<b>To:</b>	RM		
<b>From:</b>	MT	<b>Email:</b>	Redacted
<b>Phone:</b>	-	<b>Date:</b>	09 September 2019
<b>Ref:</b>	HE543917-ATK-LHA-LN-ZL-000071 C01	<b>cc:</b>	EB / SW
<b>Subject:</b>	A2BE - Proposed Modification (MOD-04) - Removal of CPO Plots 2/9a, 2/10a & 2/11a - Impact on Published Orders

## 1. Removal of CPO Plots 2/9a, 2/10a & 2/11a Modification (MOD-04)

Figure 1. Published Made Compulsory Purchase Order – Sheet 2 extract

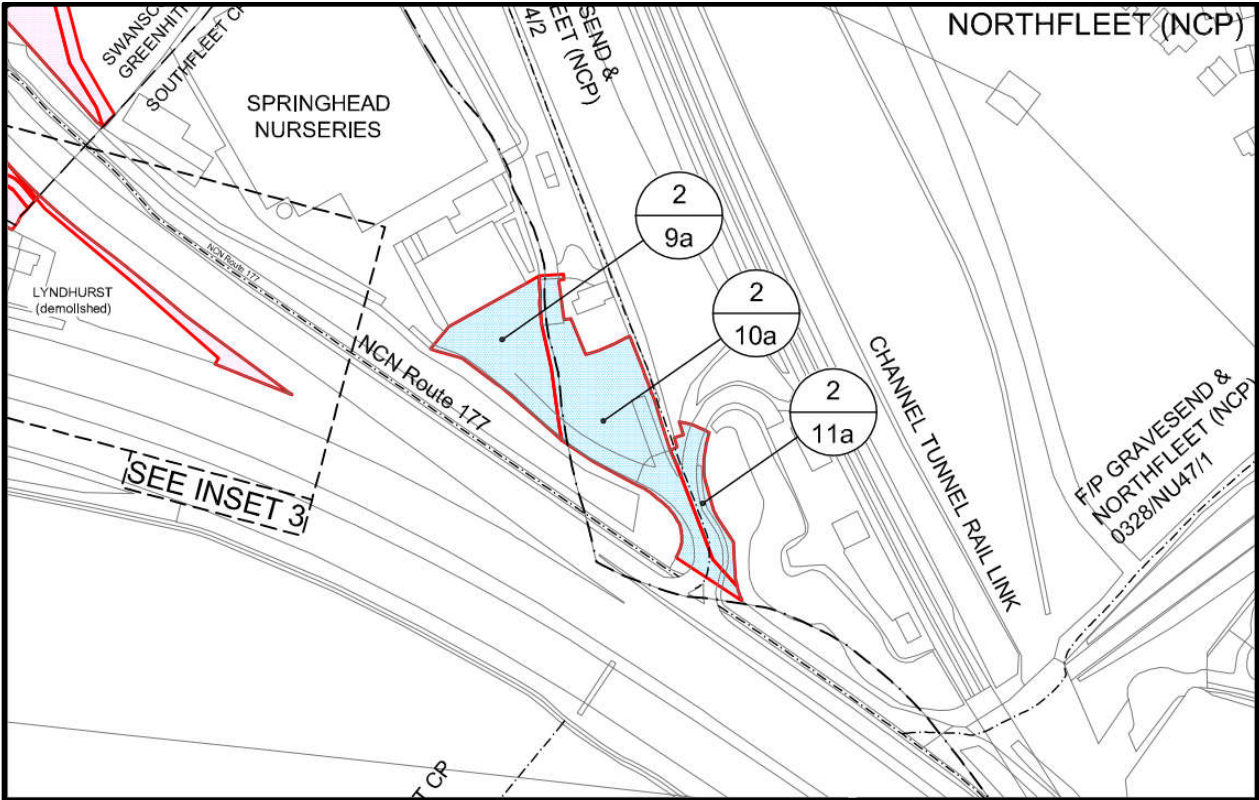
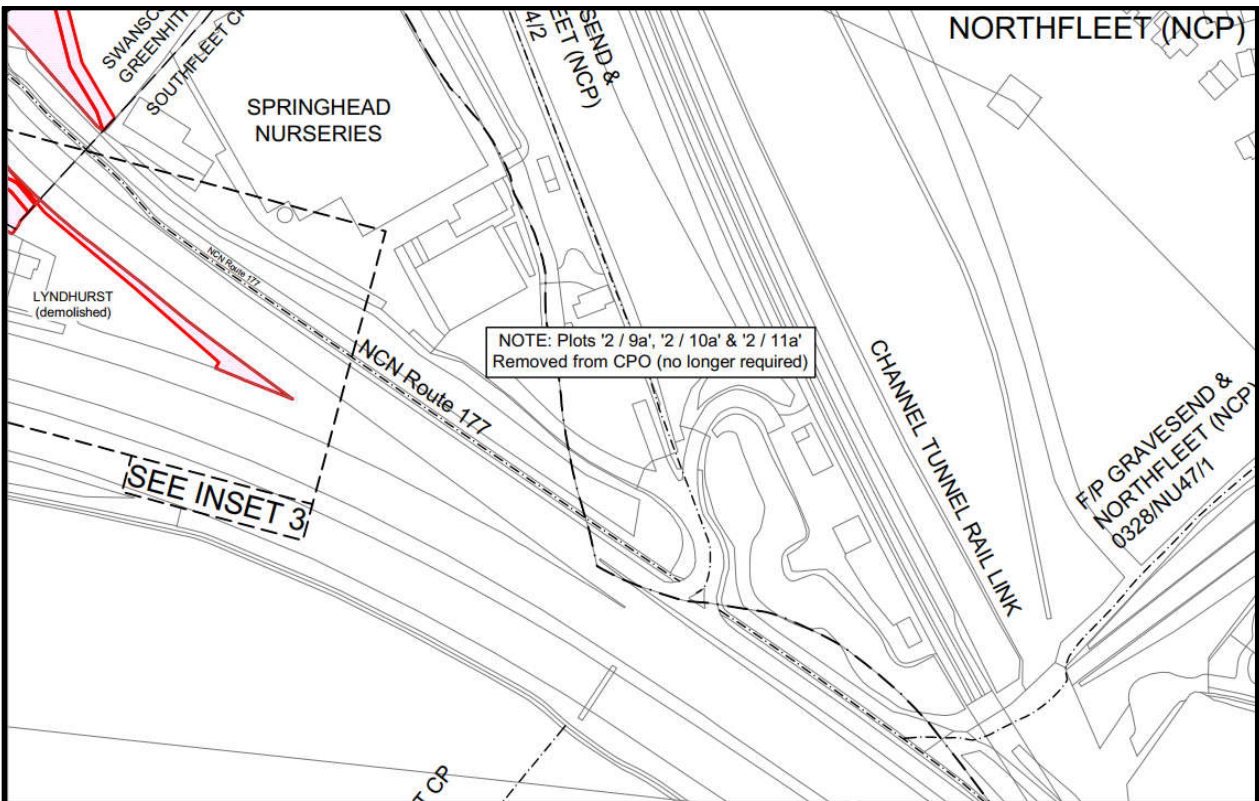
In summary, a modification is proposed to the published preliminary design (included within the February 2019 published Orders) to remove the requirement to access and alter any of the existing drainage works within Springhead Nurseries car park area or utilise their existing access road from the A2 eastbound carriageway.

Following a review of the proposed drainage design and further to additional investigations into existing rights associated with the existing drainage manholes, drainage runs and access arrangements within the vicinity it has been determined that no access rights or works would be required over and above those already in existence.

Plots 2/9a, 2/10a and 2/11a will be removed from the CPO. Figures 1 & 2 overleaf identify Plots 2/9a, 2/10a and 2/11a on CPO Sheet 2 (Figure 1) and the same area with the Plots removed (Figure 2).

Amendments will also be required to the CPO Schedule to identify the Plots removed. It is not proposed to add any new plots in respect of those removed.
